3501303 CEMENT CONCRETE PAVEMENT

COMMENTS FROM INTERNAL/INDUSTRY REVIEW

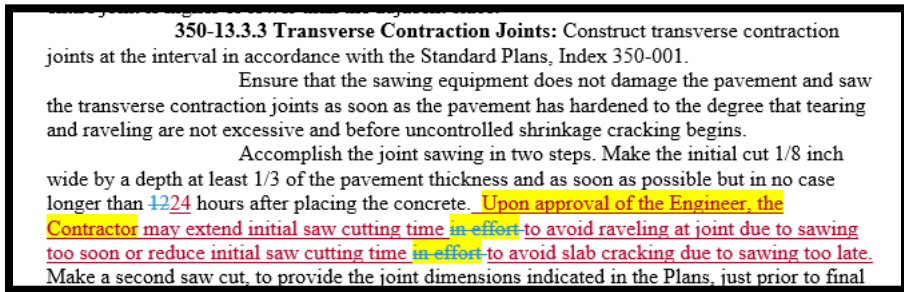
I know the last paragraph of the specification still leaves the responsibility on the contractor to “Repair any uncontrolled cracks at no expense to the Department by removing and replacing the pavement across the full width of all affected lanes or shoulders and to the nearest transverse joint in each direction” However, I would add a little bit of language to the spec to make it abundantly clear that this is at their request and at their risk. The Engineer, at the request of the contractor, may extend the time to avoid raveling at joint due to sawing too soon. The Engineer, at the request of the contractor, may reduce the time in effort to avoid slab cracking due to sawing too late. Make a second saw cut, to provide the joint dimensions. indicated in the Plans, just prior to final grinding and sealing the joint. Repair any uncontrolled cracks at no expense to the Department by removing and replacing the pavement across the full width of all affected lanes or shoulders and to the nearest transverse joint in each direction

Of the 2 new sentences added, why include “in effort” in 2nd sentence, but not in 1st sentence? Seems inconsistent

Response: Change made to state, “Upon approval of the Engineer, the Contractor may ...”

Action(s): See highlighted proposed language changes in Spec document (Image below).

Response: The phrase “in effort” was deleted from the spec change language. Language is now consistent.

Action(s): See highlighted edited language in Spec document.(Image below)
